# Witness Statement

Planning Scheme Amendment C 241

## **Amendment C241 Whittlesea Planning Scheme**

Appropriate Separation Distance  
Proposed Recycled Water Treatment Plant  
Yarra Valley Water

Figure 1. Case B: 99.9 Percentile Odour levels– Proposed Wollert RWTP

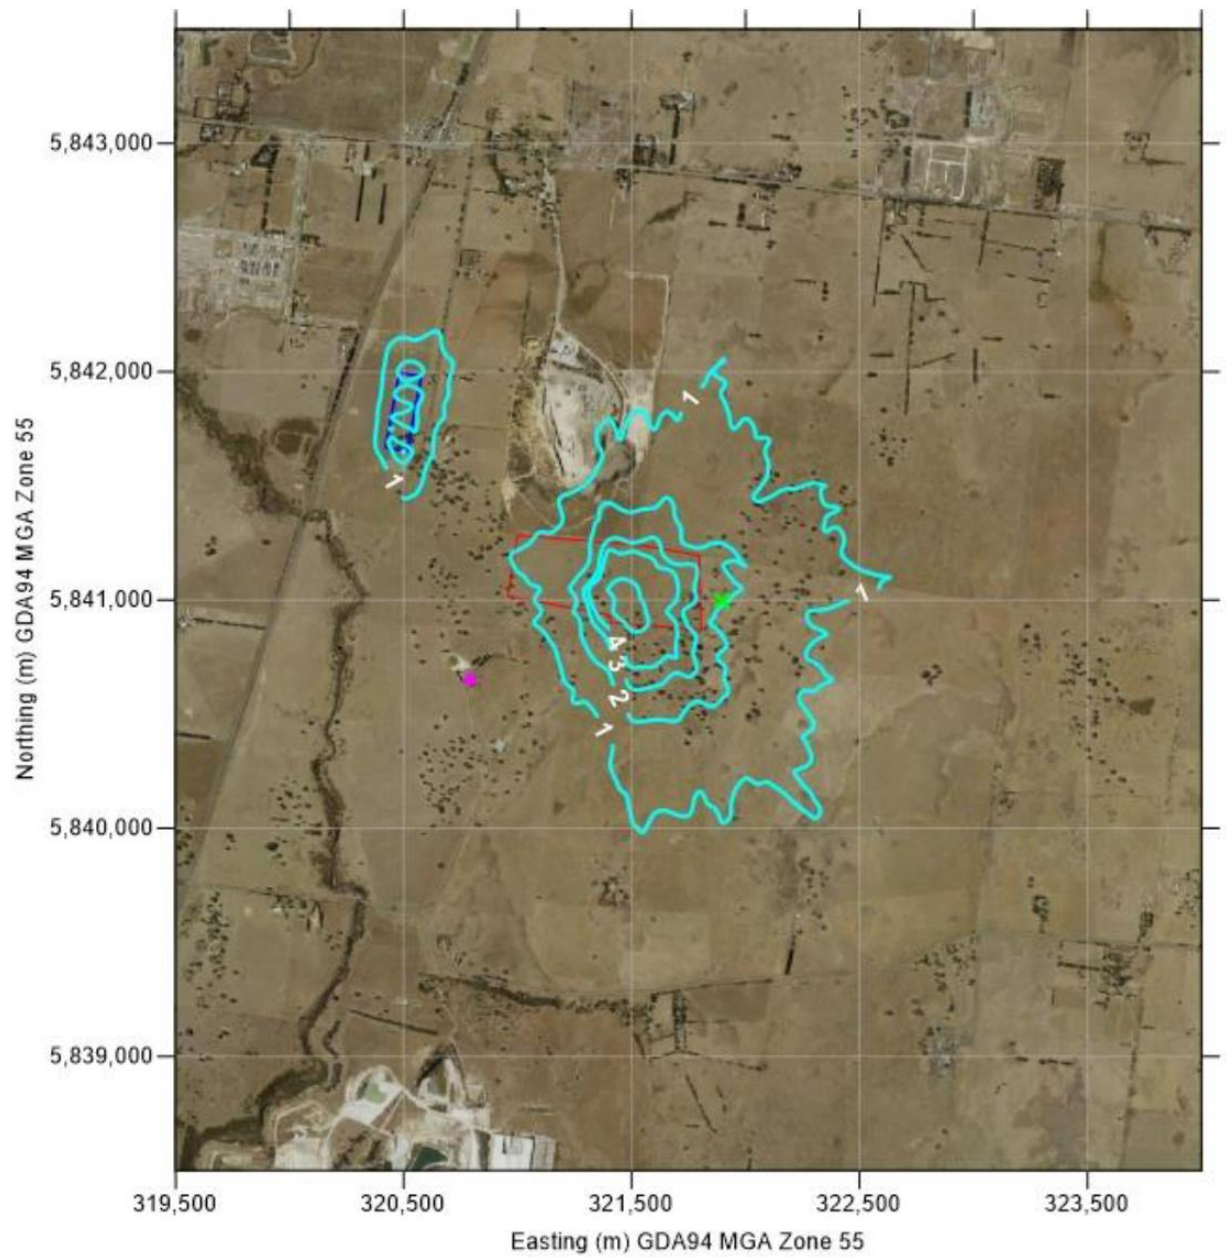
Jacobs provide contour plots of predicted peak 99.9%ile odour levels for Cases B, C E and F. These plots give an indication of the directional variation of odour impact and the plots for Cases B and E are repeated below as Figures 1 and 2.

Both Figures show a similar pattern of impact with a clear lobe of poor dispersion to the SSW and a wider lobe to the NW quadrant. The extension to the west and south west is a minimum reflecting the very low incidence of winds from the east and north east. These model outputs (if expressed as 99.5%ile rather than 99.9%ile) can be used directly to form a directional buffer – as detailed below

Figure 3. Recommended Directional Separation Distance @ 150 l/ep/d – Wollert RWTP

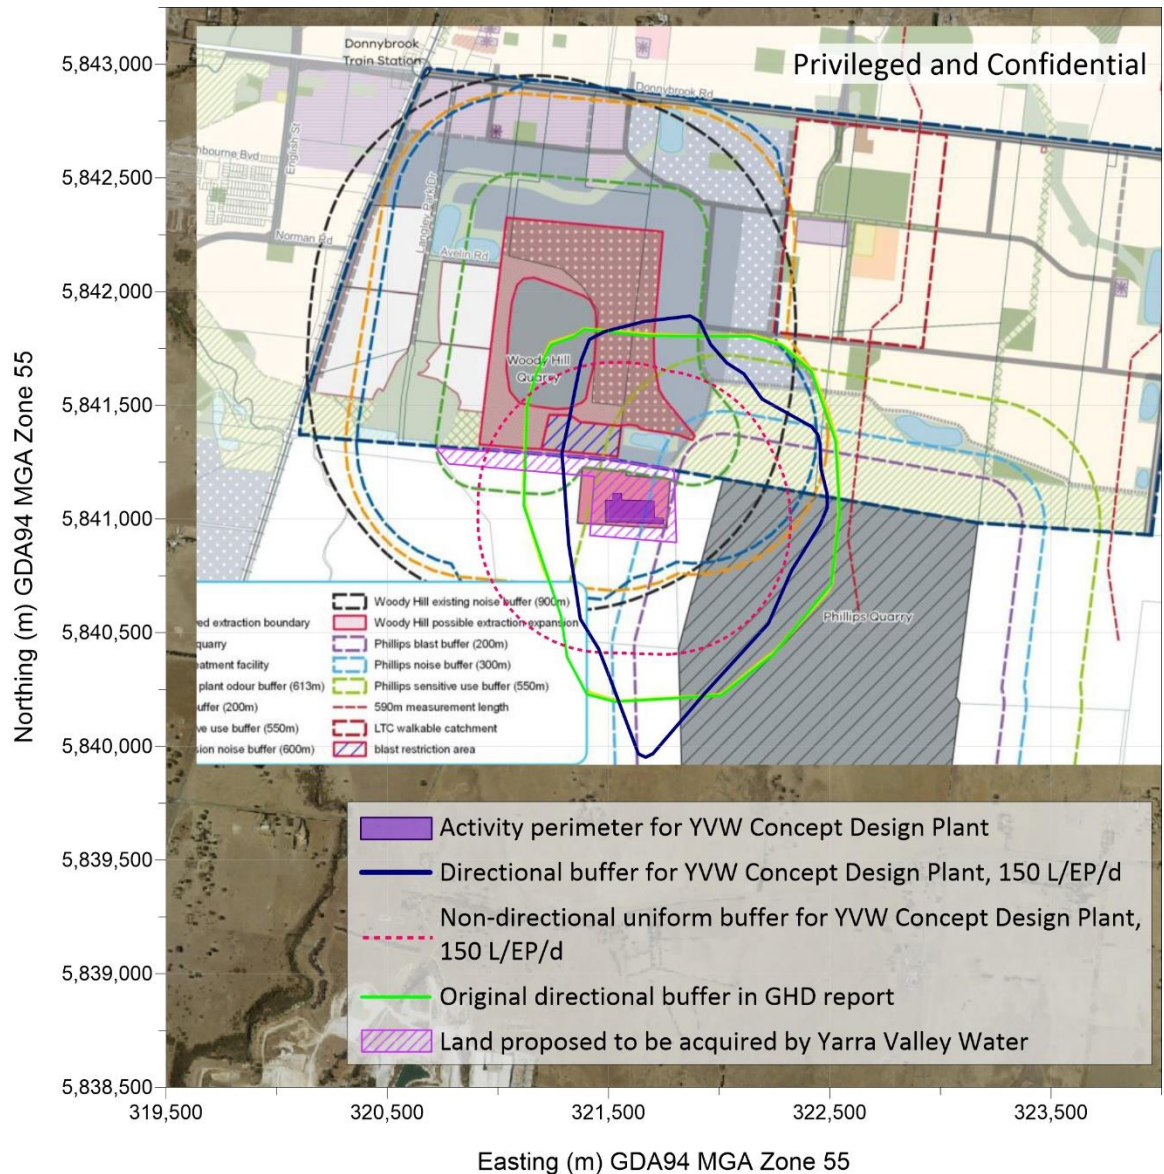
The default 575 m radial buffer in Figure 3 is shown as the broken pink line, while the corresponding directional buffer is shown as the solid blue line.

Comparing the coverage of each contour it can be seen that the directional buffer is significantly retracted to the west (up to 400 m), and is extended to the south, ENE and NNE by ~ 450, ~250 and ~ 250 m respectively.

The equality of included area for each contour can be visually gauged by seeing that the area lost to the west by the directional buffer referenced to the radial buffer is balanced by the extensions east, south and north of the radial buffer.

- I agree with both GHD and Jacobs that the meteorological data from Tullamarine is representative of wind climate at the Wollert RWTP.
- Site-representative meteorology at the Wollert RWTP shows distinct lobes of good and poor dispersion, meriting variation from the default separation distance via the fifth criterion in *Table 4* of the Guideline.
- I consider the procedure outlined in Section 4.2 is an effective method to form a directional separation distance for the proposed Wollert RWTP.
- The recommended directional separation distance for Wollert RWTP is shown in Figure 3 for a per capita flow of 150 l/d/ep and an ultimate Plant flow of 28.5 ML/d.
- I agree that the directional buffer shown in Figure 3 is appropriate to apply to the proposed Wollert RWTP.
